RE: Encroachment approval for Springs at Waterview Filing 1

Reference is made to your proposal to encroach into the 5' side lot and 5' rear lot easements in the Springs at Waterview Fil 1 Development.

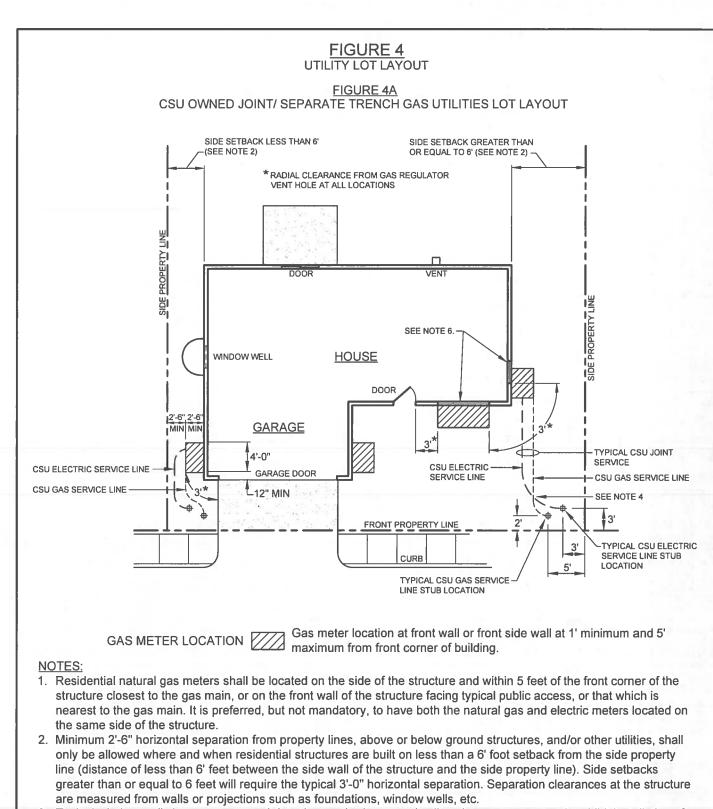
- 3. Typical window well sizes may encroach into the required gas service line clearance space and prohibit installation of the gas service line past that point. The electric service wire may be able to pass by the window well as long as there is the required 12" clearance from the electric service wire to both the window well and the property line.

- 4. If electric and gas service lines ever need to cross each other, maintain 12" vertical separation between the crossing lines, and maintain 6" bedding sand above and below gas service line.

- 5. See Figure 4B for Non-CSU Utilities Lot Layout .
- 6. Operable window requires 3' radial separation from gas regulator vent hole. Non-operable window is required if located within 3' of gas regulator vent hole (typical).

- 7. See Figure 9A, 9C and notes for additional requirements regarding meter location.
- 8. All meters on town homes and single family residential buildings shall be easily accessible for maintenance with no enclosures or fencing.

CSU OWNED JOINT/SEPARATE ELECTRIC UTILITIES LOT LAYOUT

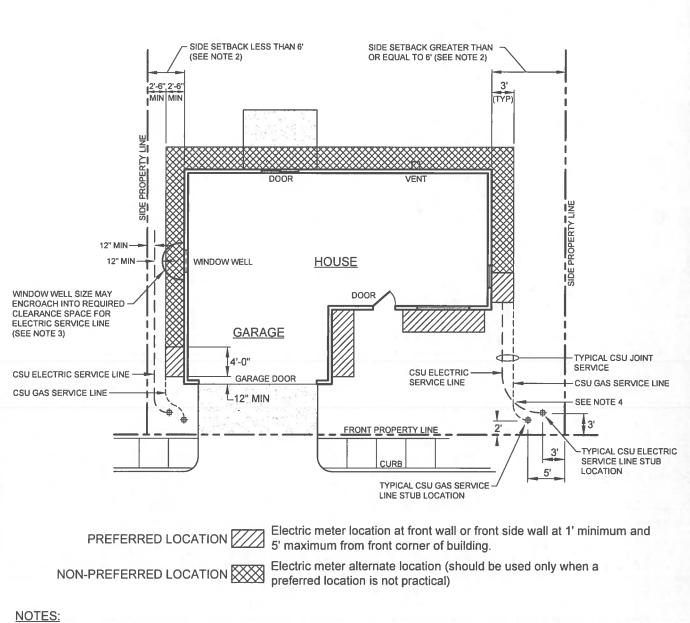
- 1. Preferred CSU residential electric meter location is on the side of the structure and within 5 feet of the front corner of the structure, or on the front wall of the structure facing typical public access. It is preferred, but not mandatory, to have both the natural gas and electric meters located on the same side of the structure.

- 2. CSU electric service line minimum 2'-6" horizontal separation from property lines, above or below ground structures, and/or other utilities, shall only be allowed where and when residential structures are built on less than a 6' foot setback from the side property line (distance of less than 6' feet between the side wall of the structure and the side property line). Side setbacks greater than or equal to 6 feet will require the typical 3'-0" horizontal separation. Separation clearances at the structure are measured from walls or projections such as foundations, window wells, etc.

- 3. The electric service wire may be able to pass by the window well as long as there is the required 12" clearance from the electric service wire to both the window well and the property line.

- 4. If electric and gas service lines ever need to cross each other, maintain 12" vertical separation between the crossing lines, and maintain 6" bedding sand above and below gas service line.
